### Service information

# Reference no.: SDA 92177

Appliance starts brewing by itself

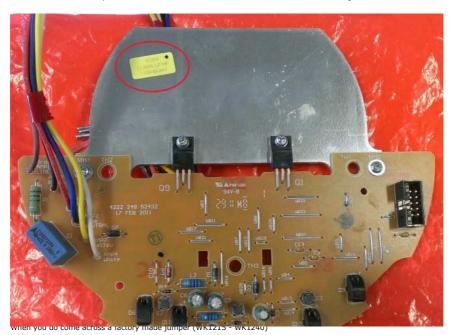
INFO:
We have received field complaints about Senseo Cappuccino Select appliances that start to brew by itself, without interaction by the consumer. This appears to be a random problem. The brewhead switch is connected to the same input of the micro controller as the two-cups button. Interference on the leads that connect the brew head switch to the interconnect PCBA may accidentally trigger the 2-cups button signal to the microcontroller, making the appliance performing a 2-cups brewing cycle. It has been decided to discontinue the brewhead detection switch altogether, therefore the Cure below is developed to disable the sensor. Risk analysis has proven that this change in functionality does not introduce a risk.

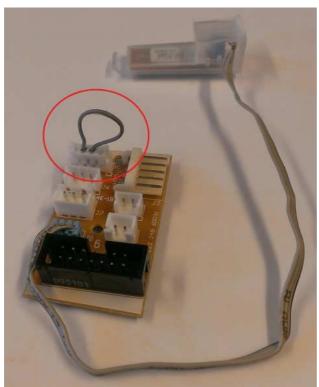
Else, open the back cover of the appliance according to the instructions in the service manual. Take out the interconnect PCBA, and remove the brewhead sensor connector (J3) from the Interconnect PCBA. Cut the wires that are left behind in the appliance (the sensor side) as close to the housing of the Brew Chamber as possible. The sensor itself must remain in place. Next, replace the PCBA (422225950283) as the latest softwareversion that is available @ DHL from WK1222 onwards, will disable the detection in the software. There is no "bad" stock left @ DHL. PCBA's with software that disregards the status of the brewhead switch can be identified by the code on the sticker on the heat sink of the PCBA: **50286** or higher

**please remove it,** as interference can still accidentally trigger the two-cup button. The header on the interconnect PCBA must remain empty!
